**NOTICE OF DECISION TO CONSENT TO CHANGE TO PROPOSAL DURING  
ASSESSMENT**

Greenbushes Lithium Mine Expansion  
Assessment No. 2172

**CONSENT TO CHANGE PROPOSAL DURING ASSESSMENT**

Figure 1: Development Envelope and Disturbance Footprint

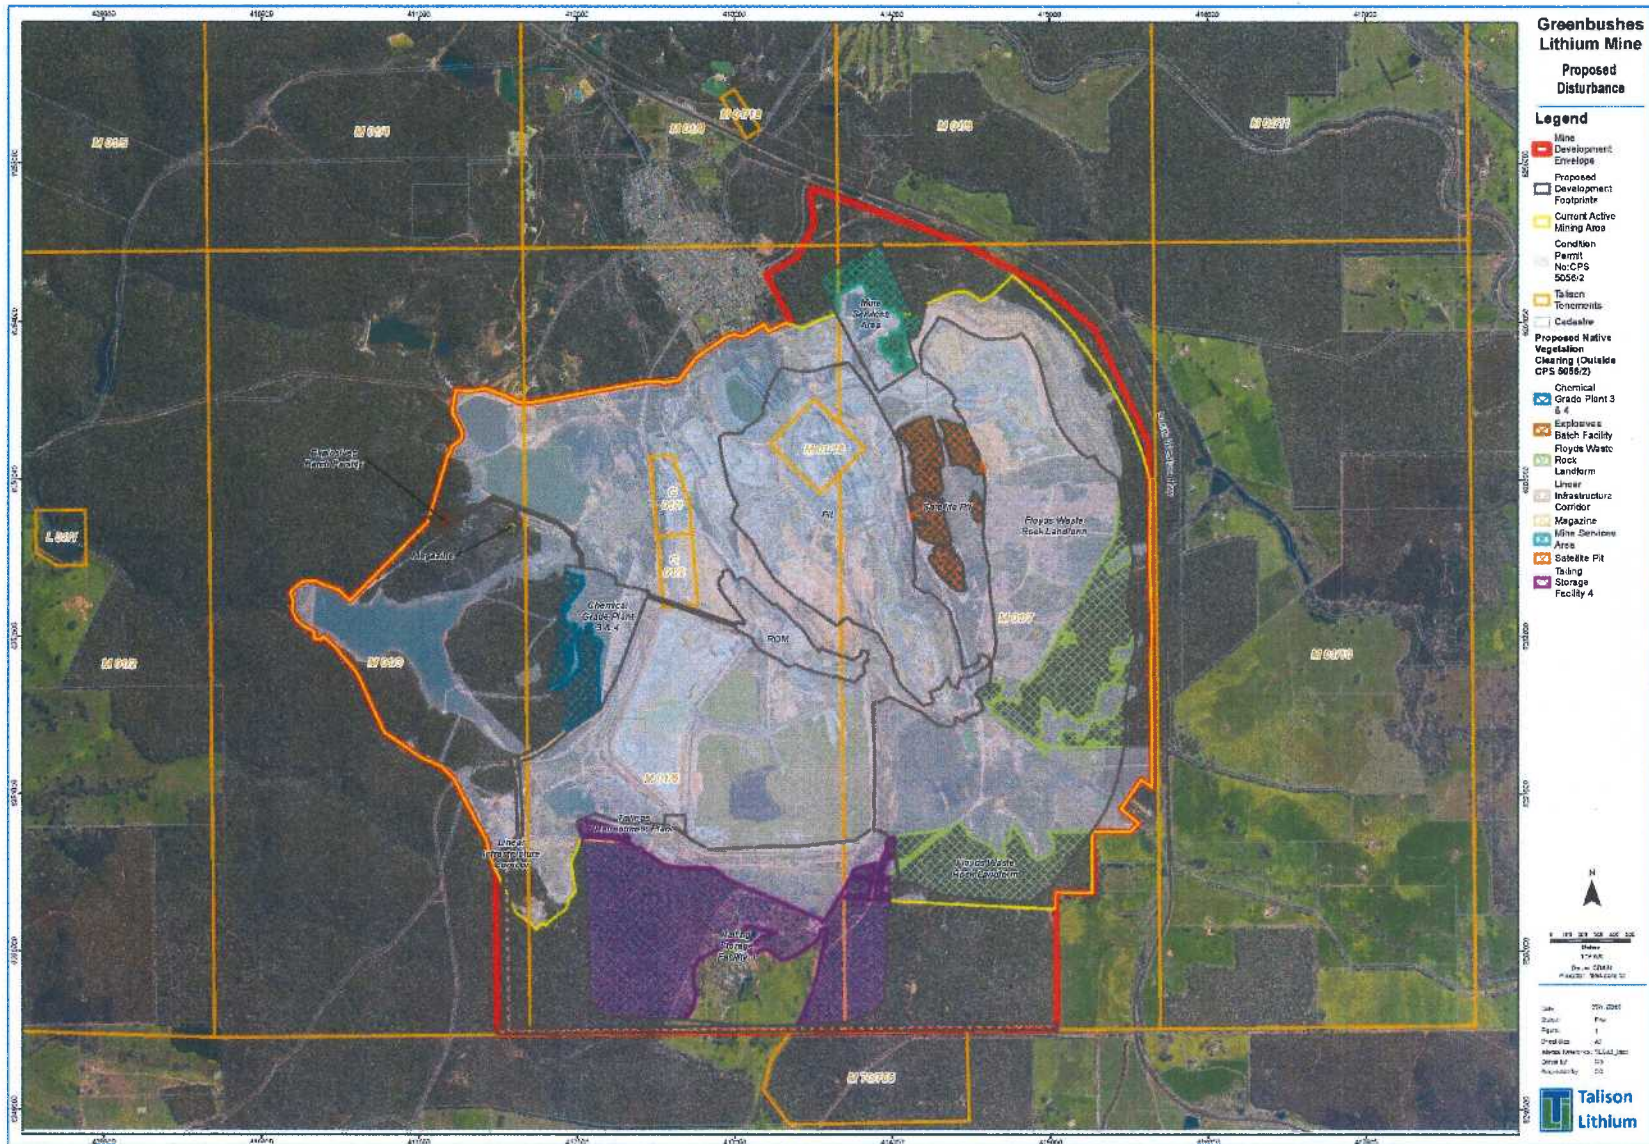
- *Inclusion of a Tailings Retreatment Plant within the final disturbance footprint of the Tailings Storage Facility 4 [this means an increase to tailings production from 8 to 9 Mega tonnes per annum (Mtpa)];*
- *Increase in the rate of ore processing (from 9.5 to 11.6 Mtpa due to the inclusion of the Tailings Retreatment Plant which will increase production capacity of lithium mineral concentrate from 2.3 to up to 2.8 Mtpa);*
- *Revision of the description of the mining rate (the maximum annual mining rate of 25 Million bank cubic metres (Mbcm) is provided instead of the 16 Mbcm that represents average annual mining rate over the life of mine); and*
- *Change in the crusher description from three-stage to a two-stage crusher.*

Figure 1: Development Envelope and Disturbance Footprint

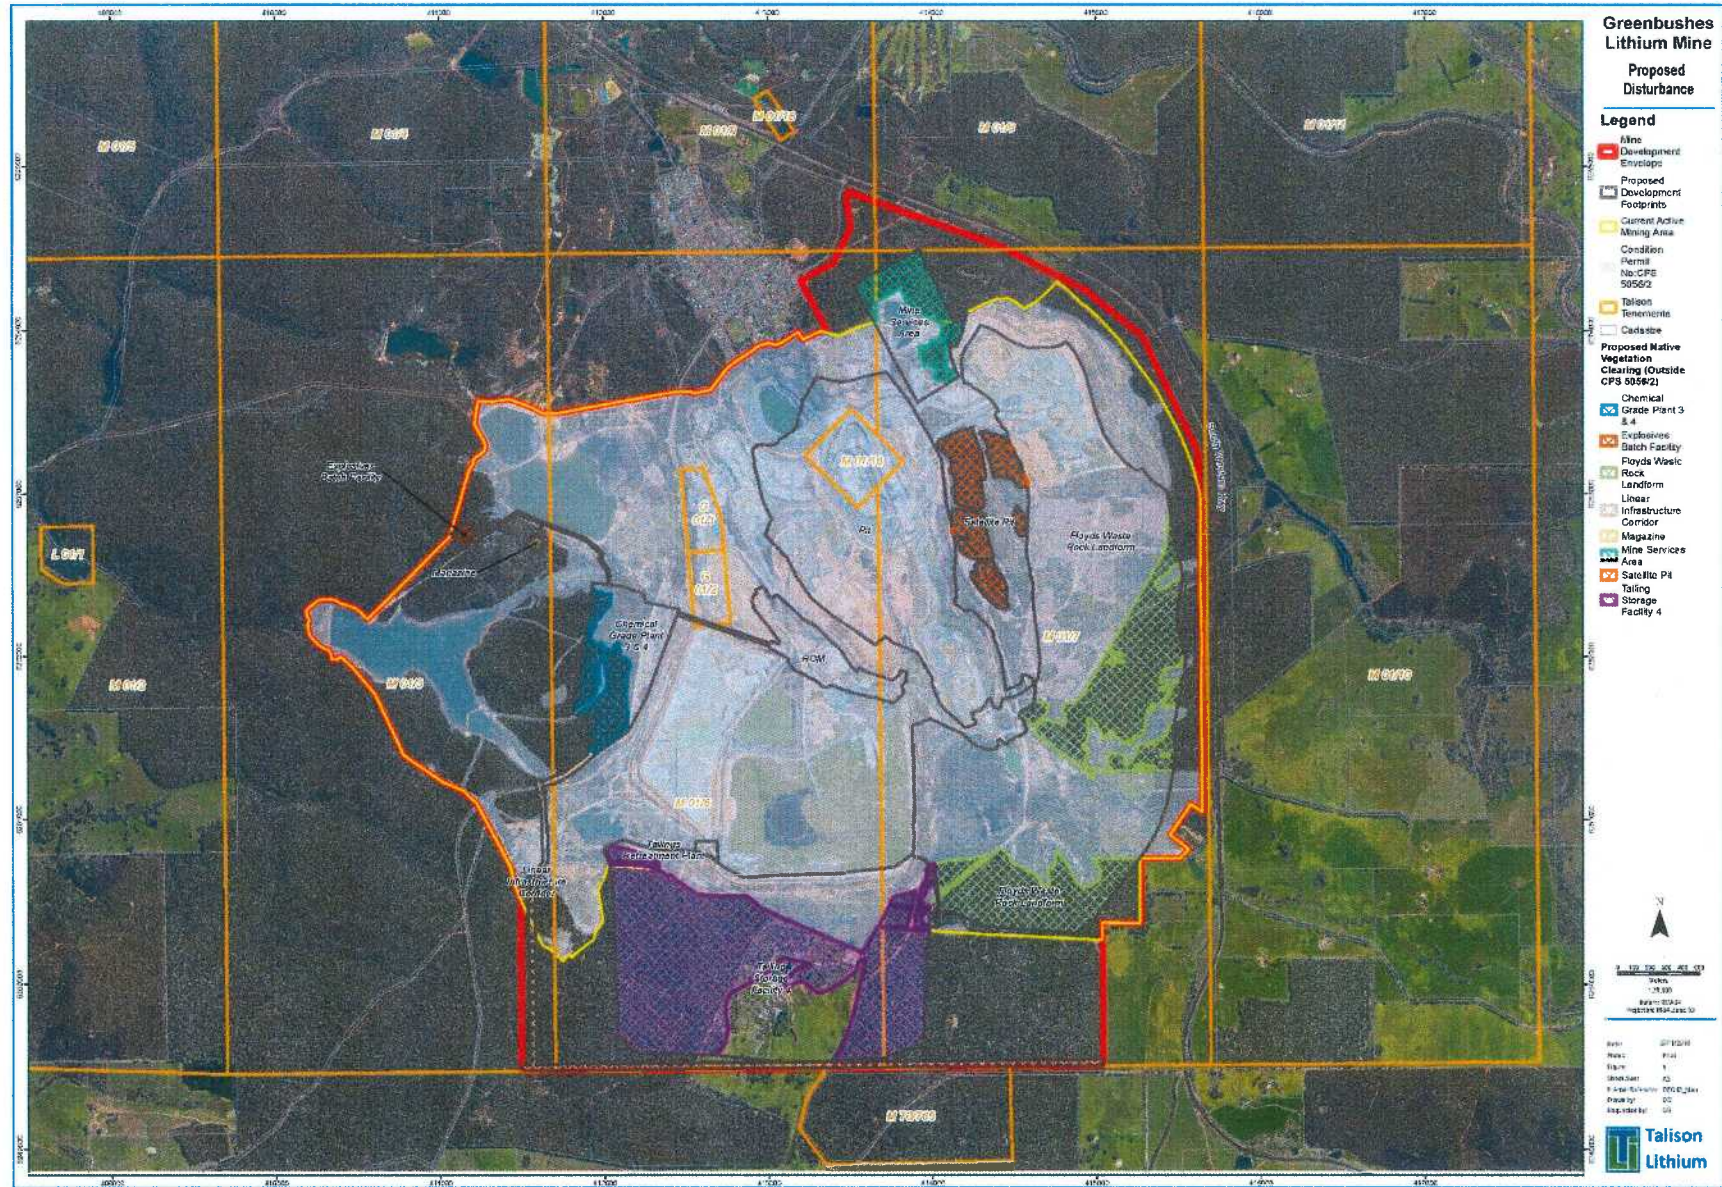
The main component of the proposed change is construction of the Tailing Retreatment Plant which will be built within the final footprint of the TSF4 and does not require any additional clearing.
